# REGIONAL REVIEW NOTIFICATION

**ARC REVIEW CODE:** R1810021

**Name of Proposal:** Equinox Corporate Campus (DRI 2809)

**EQUINOX CORPORATE CAMPUS – DRI 2809**  
**City of Alpharetta**  
**ARC Natural Resources Group Review Comments**

DESCRIPTION  
DATE  
NO. BY  
DRAWN BY  
CHECKED BY  
DATE  
SHEET TITLE  
GRTA DRI  
SITE PLAN  
SHEET NUMBER  
DRI-1

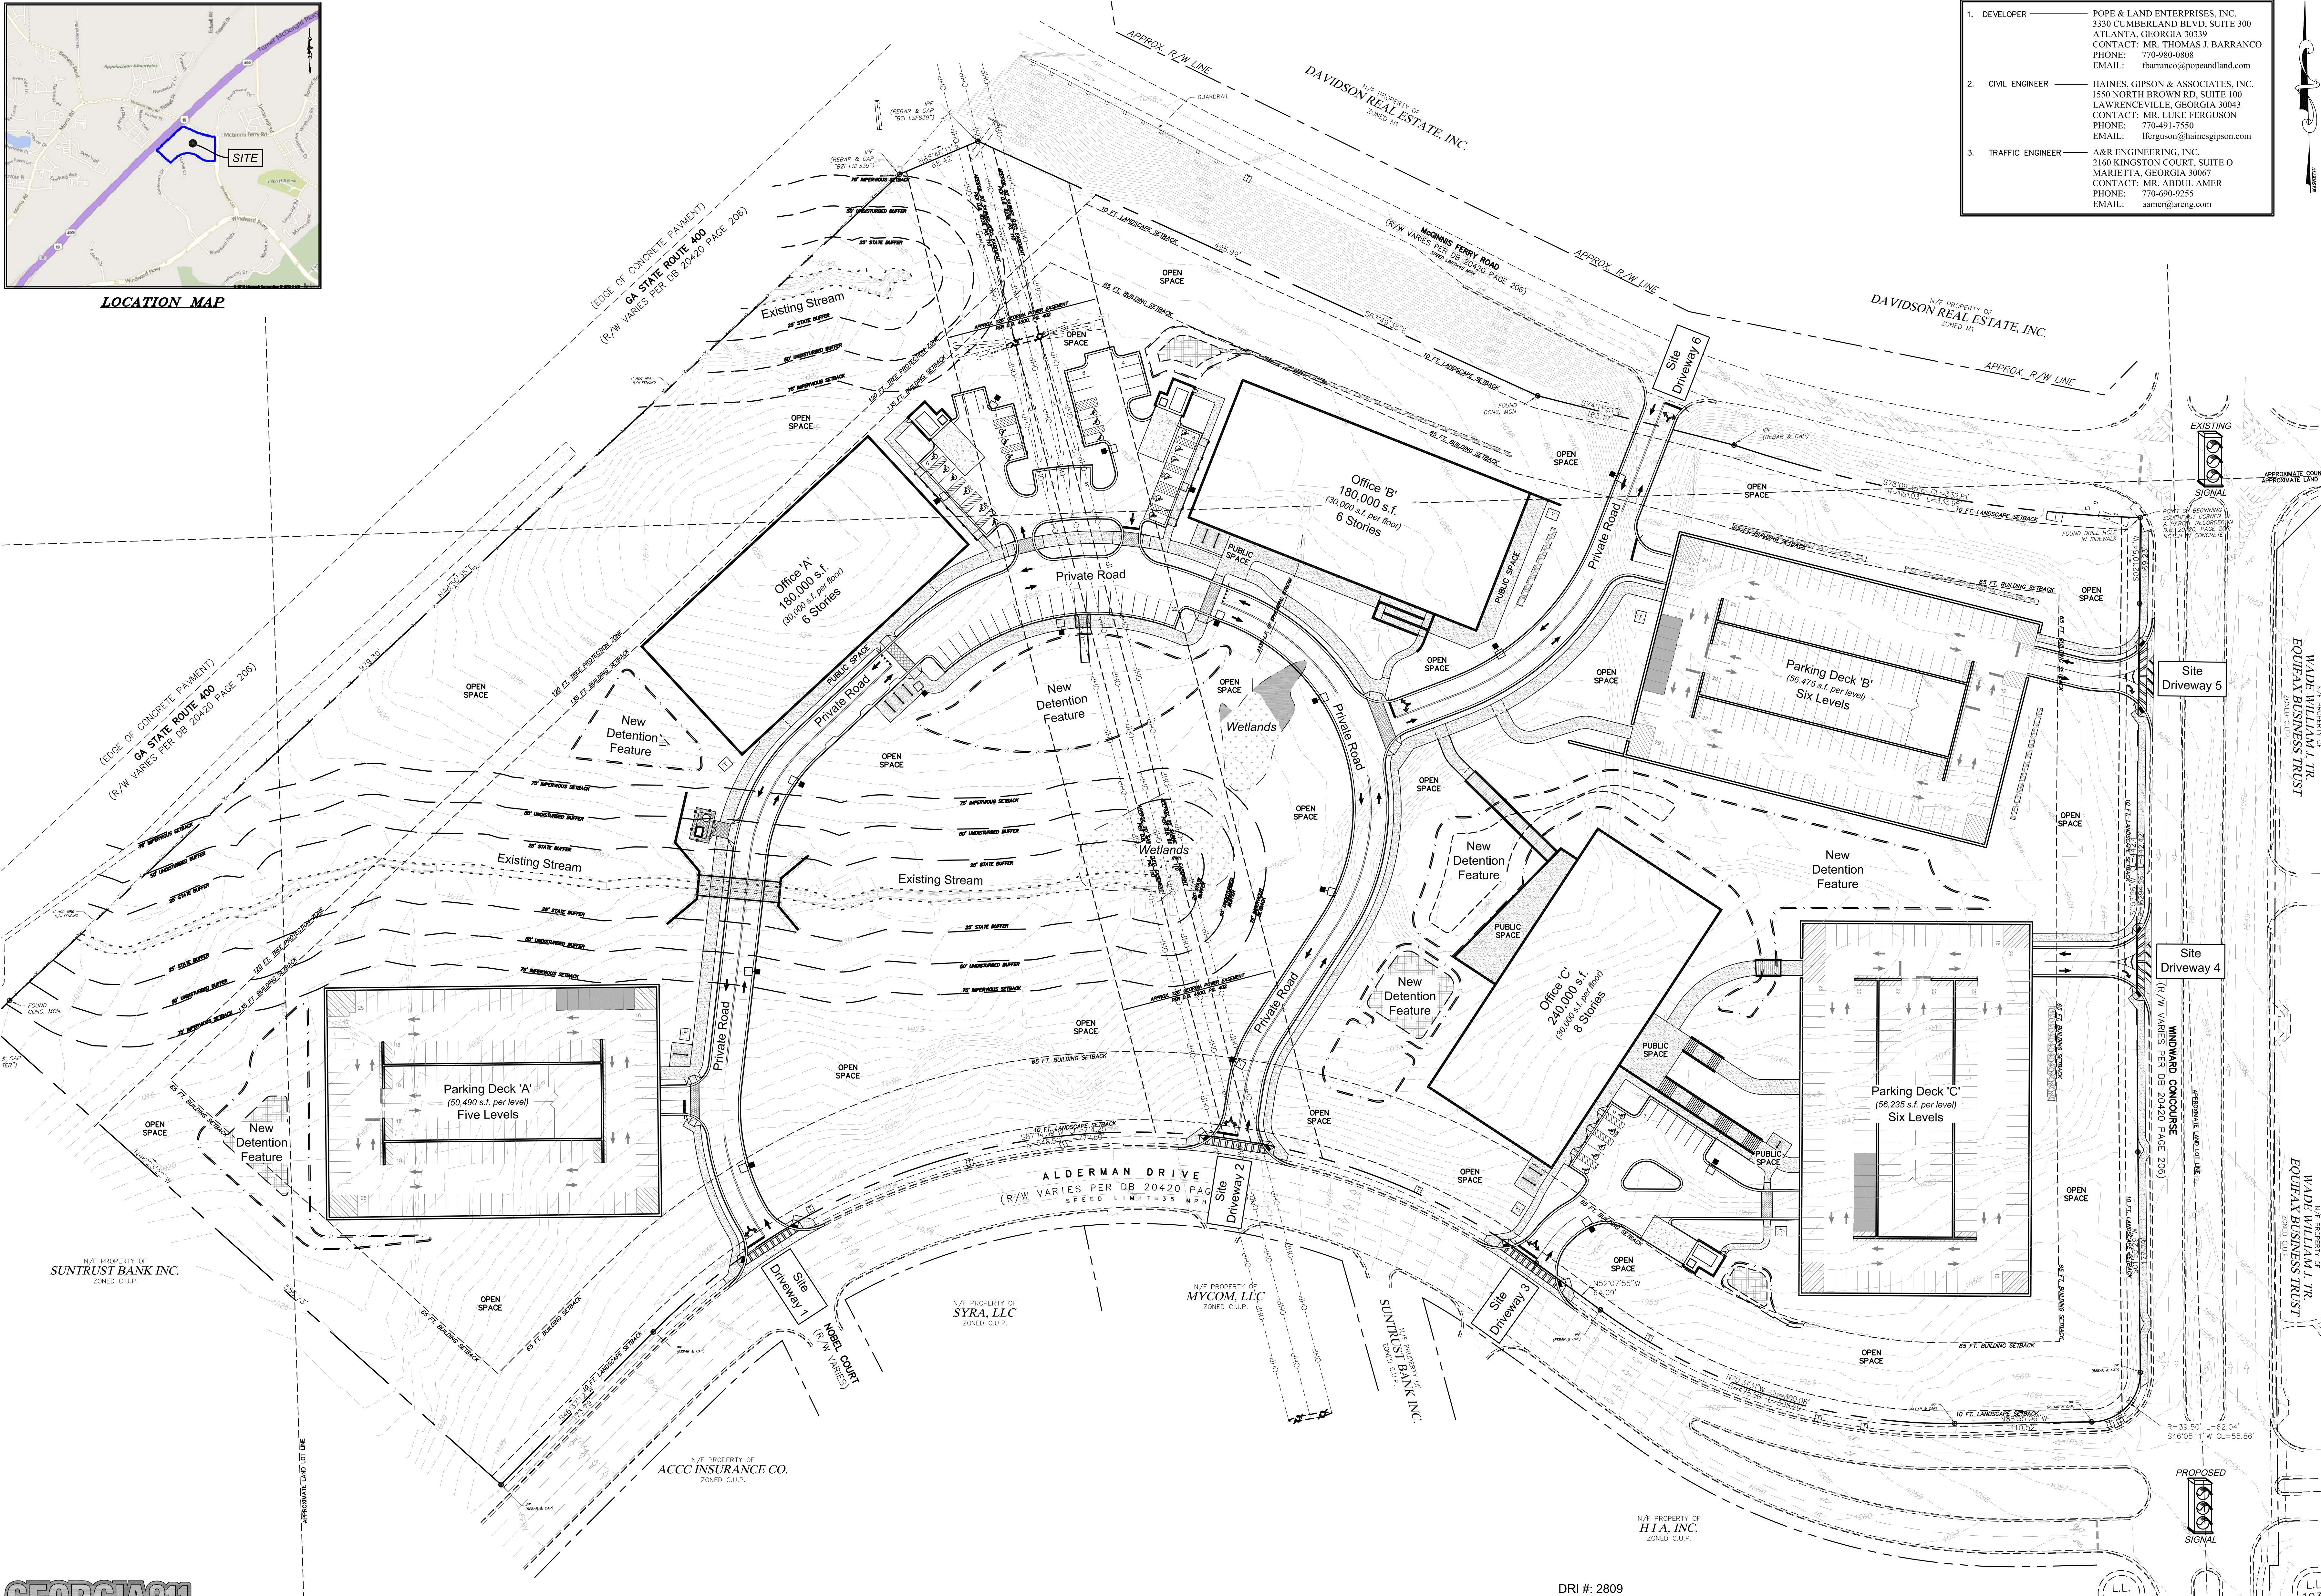
This DRI appears to manifest certain aspects of regional policy. The plan contemplates a 600,000-sq. ft. office development, supporting regional economic development efforts. The development also features access to multiple area roadways, preventing a cul-de-sac/pod scenario in terms of site access. Care should be taken to ensure that the development promotes an interconnected, functional, clearly marked and comfortable pedestrian experience on all streets, paths and parking areas. The site plan proposes pedestrian pathways connecting all office buildings and parking decks, as well as a new sidewalk on the project's Windward Concourse frontage. This new sidewalk will support pedestrian circulation in the area in general. Specifically it will allow MARTA Bus Route 143 riders to walk north from the stop (on Windward Concourse just north of Alderman Drive), enter at Driveway 4 or 5, and navigate through Parking Deck B or C to reach the office buildings. However, ARC also recommends that the development team provide a sidewalk along the project's Alderman Drive frontage, such that bus users can walk west from the stop to access the DRI site via Driveways 2 and 3. This is likely a shorter and less circuitous route to the project's office buildings than entering on foot at Driveways 4 or 5.

In terms of bicycling, striping and/or signage for bike use is already present on Windward Concourse, Alderman Drive and Windward Pkwy., and the project is within a relatively short biking distance from nearby residential and commercial areas. The development team is therefore encouraged to ensure that end-of-trip facilities (bicycle racks, showers, etc.) are provided for workers at key locations on site. This framework can offer the potential for workers to commute by bike, and it can offer those workers access to certain daytime needs (meals, goods, etc.) without adding car trips to the road network. The project can further support The Atlanta Region's Plan in general by incorporating other aspects of regional policy, including green infrastructure and/or low-impact design, e.g., rain gardens, vegetated swales, etc., in parking areas and site driveways, and as part of any improvements to site frontages.

Site access is provided by six access points on Alderman Drive, Windward Parkway and McGinnis Ferry Road.

The development proposes sidewalks internal to the site connecting pedestrians to uses within the development. Existing sidewalks are along Windward Concourse and McGinnis Ferry.

The development proposes sidewalks internal to the site connecting pedestrians to uses within the development. No bicycle facilities are proposed.
